PAPA JOHN'S SUBDIVISION

APPLICATION NUMBER 6 DATE November 20, 2008

REQUEST Subdivision

DETAIL SITE PLAN

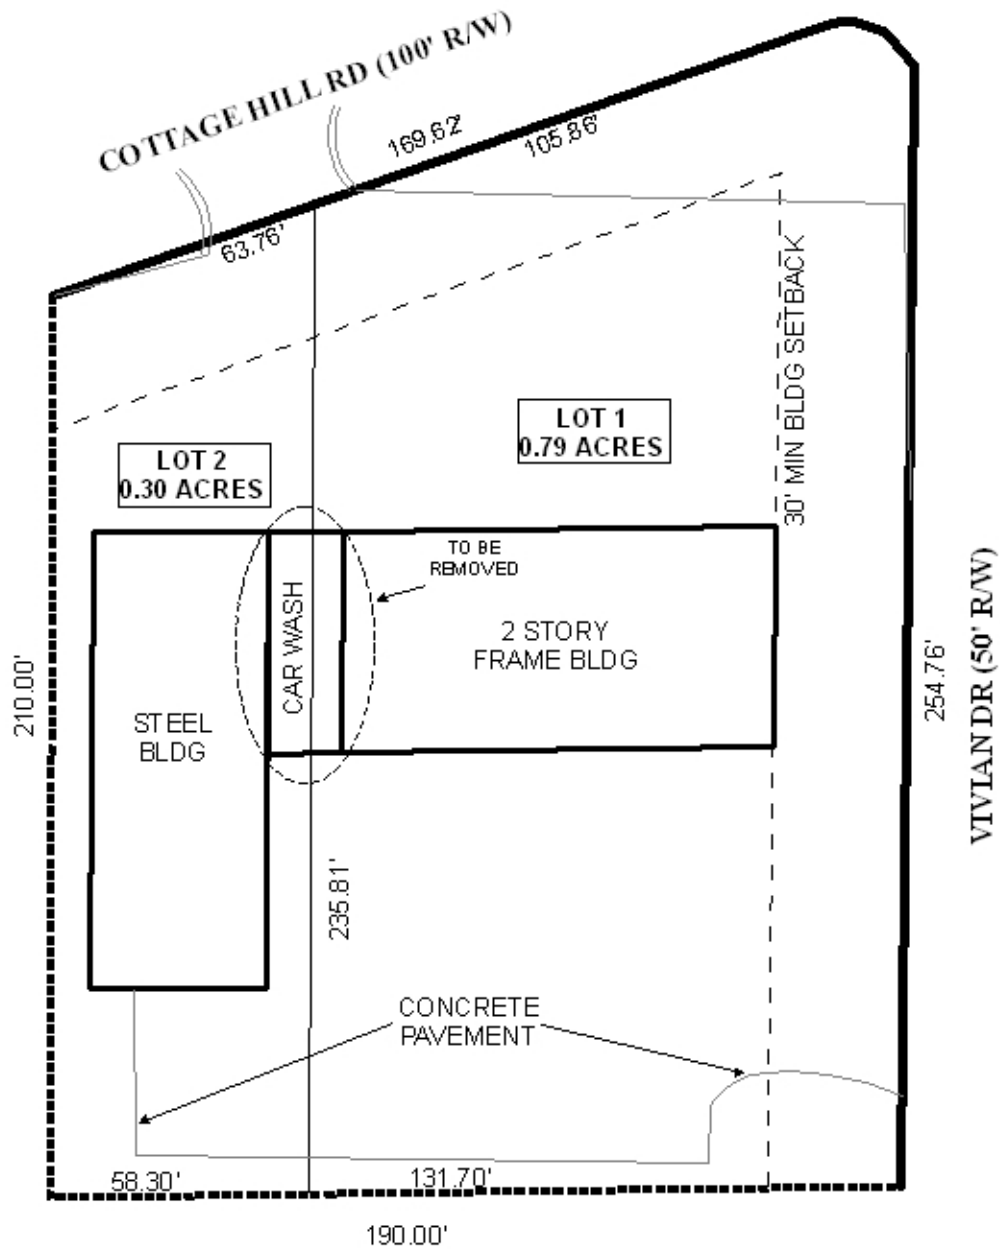
To the North, the site fronts Cottage Hill Road, a major street with sufficient right-of-way. To the East, it fronts Vivian Drive, a minor street with 50' right-of-way. Section V.B.14. of the Subdivision Regulations requires that minor streets without curb and gutter have a minimum 60' right-of-way. Thus, the applicant should revise the plat to provide a minimum 30' as measured from the centerline of Vivian Drive.

The subject site is currently developed with existing curb cuts to Cottage Hill Road and Vivian Drive. The proposed subdivision, as illustrated on the plat, would create a situation where two lots share access from Cottage Hill Road. It also appears that there will be shared parking on the Southern portion of the site. Therefore, an application for a Planned Unit Development would be required.

Lot 1 has approximately 255' of frontage, with an open continuous curb cut, along Vivian Drive. If approved, the continuous curb cut shall be removed, and a note should be placed on the final plat stating that Lot 1 is limited to two curb cuts to Vivian Drive, with the size, location, and design to be approved by Traffic Engineering and conform to AASHTO standards.

As illustrated on the plat, the applicant plans to demolish a portion of the existing structure, thereby creating two separate buildings. However, the resulting building on Lot 1 appears to be very close to the interior lot line. As required by Section 64-3.E. of the Zoning Ordinance, structures must be either zero or five feet from side property lines in B-2, Neighborhood Business Districts (nothing in between). Therefore, the applicant should revise the plat to label all setbacks, in order to verify compliance.

Based on the preceding, it is recommended that this application be held over until the December 18th meeting to allow the applicant to submit an application for a Planned Unit Development, for shared access between two building site, and to depict the proposed building setbacks from the interior lot line.
